Remarks

U.S.S.N. 10,723,072

For: Single Transistor Ram Cell And Method Of Manufacture Attorney Doc. No.: 67,200-1178

Figure 1F

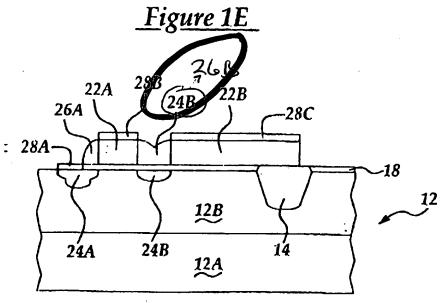
The drawings have been amended and a proposed replacement sheet submitted to correct "24B" to "26B" in Figure 1F to make it consistent with Figure 1E and the Specification.

Please replace "24B" in Figure 1F, pointing to a dielectric portion between pass transistor 22A and storage capacitor 22B, with "26B" to make Figure 1F consistent with the Specification and with Figure 1E.
